<b>Notice of Allowability</b>	Application No.	Applicant(s)	
	10/726,065	DAHULICH, WAYNE G.	
	Examiner	Art Unit	
	Tamara L. Graysay	3636

**ATTACHMENT 7: *Examiner's Comment***

FIG. 5

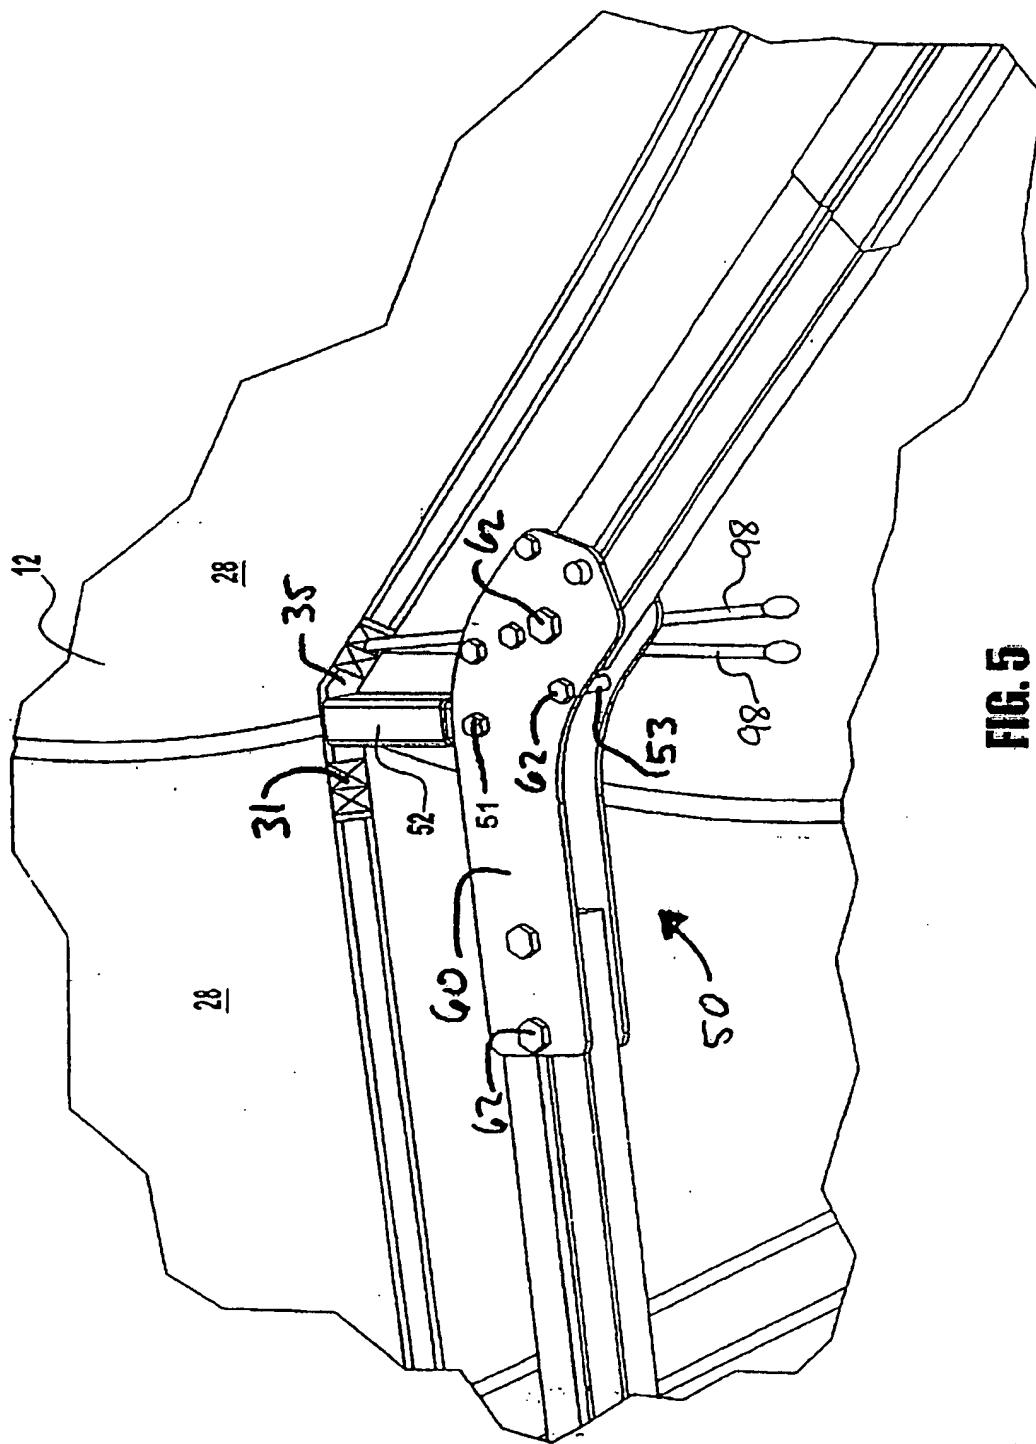
2. The changes to the drawings, as noted on the three annotated sheets submitted 04 August 2006, have been approved by the examiner, subject to correction of the informalities indicated on the attached "Notice of Draftsperson's Patent Drawing Review," PTO-948 (Attachment 2). In order to avoid abandonment of the application, applicant must make the drawing changes.

*Approved*  
*[Signature]*

FIG. 8

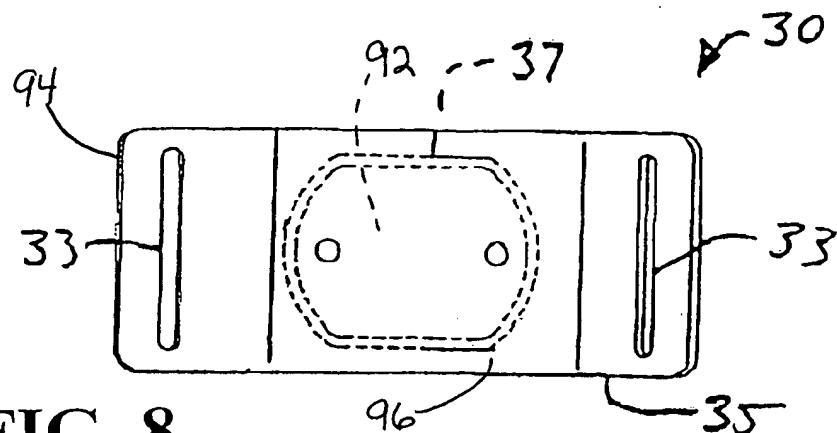
*Approved  
GS*
